TOWN OF BLUFFTON
HISTORIC PRESERVATION COMMISSION

MEETING DATE:	February 5, 2020
PROJECT:	7 Blue Crab Street – Carriage House
APPLICANT:	Randolph Stewart
PROJECT MANAGER:	Katie Peterson, AICP, Senior Planner

PLAN REVIEW COMMENTS FOR COFA-11-19-013711

MEETING DATE:	February 6, 2020
PROJECT:	25 Pritchard Street – Carriage House
APPLICANT:	Andrew Pietz
PROJECT MANAGER:	Katie Peterson, AICP, Senior Planner

3 / A301 FRONT ELEVATION W. CARRIAGE HOUSE

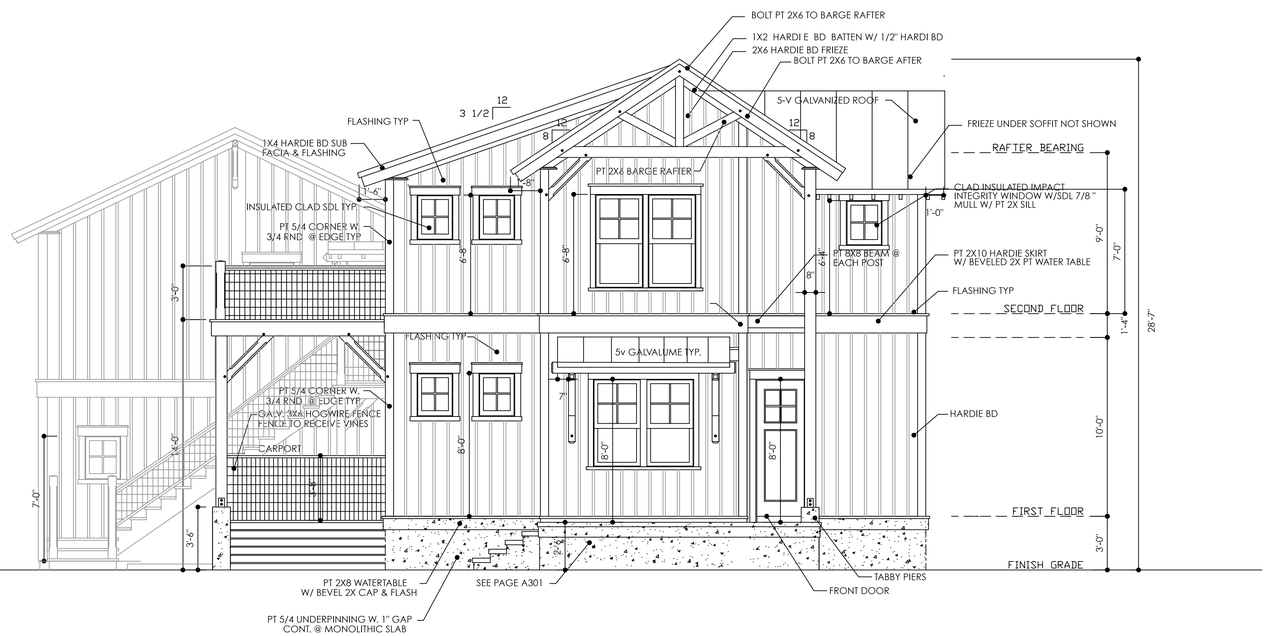
2. The UDO requires that columns shall be spaced no farther apart than they are tall. Columns are proposed as further apart on center than they are tall at the breezeway between the primary structure and the carriage house. The column placement must be revised to meet this requirement. (UDO Section 5.15.6.H.1.a. and Traditional Construction Patterns Section 52)

3.As the project moves toward Final submittal, a letter of approval from the Tabby Roads HARB is required. (Applications Manual)
4. The primary entrance to all buildings shall be located on the exterior wall facing the frontage street. The proposed plans show a door on the elevations, but it does not show on the floor plans as the primary entrance. The plans must be revised to provide the primary entrance on the elevation fronting Bruin Road. (UDO 5.15.6.I.1.a.)

Appendix E-Service Yard

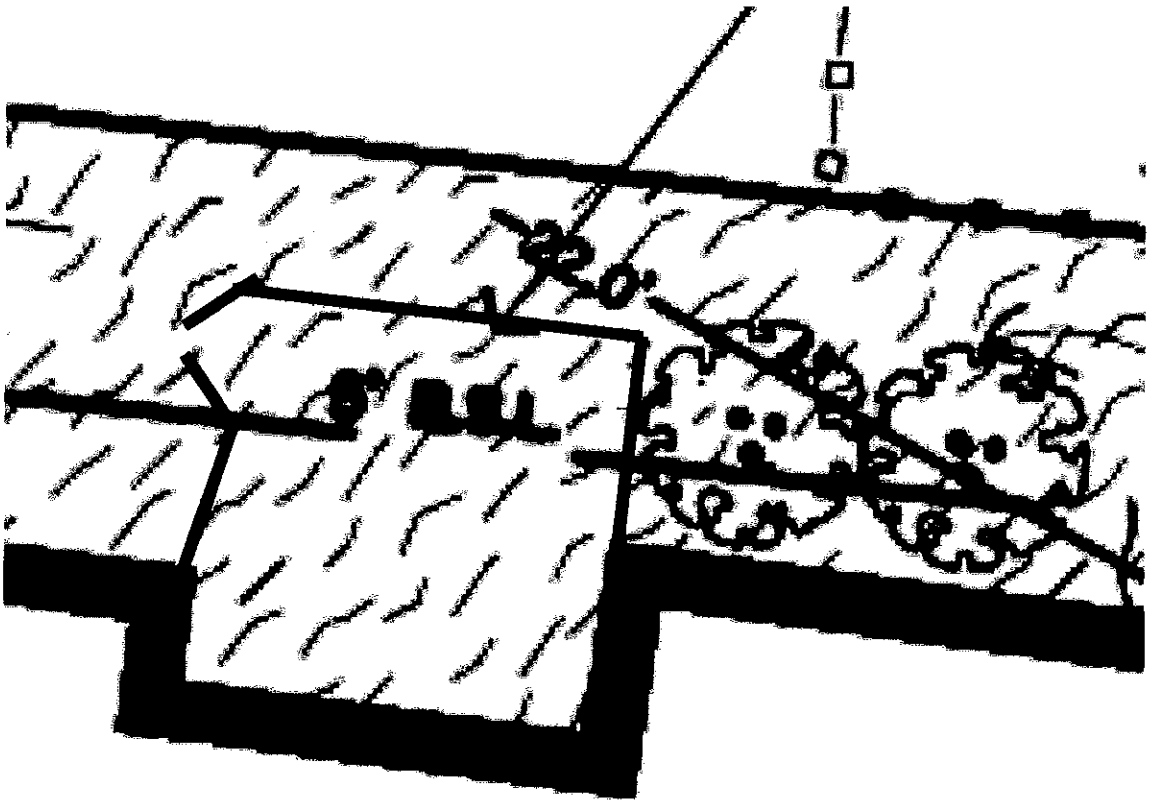
Fenced in Service yard with access gate
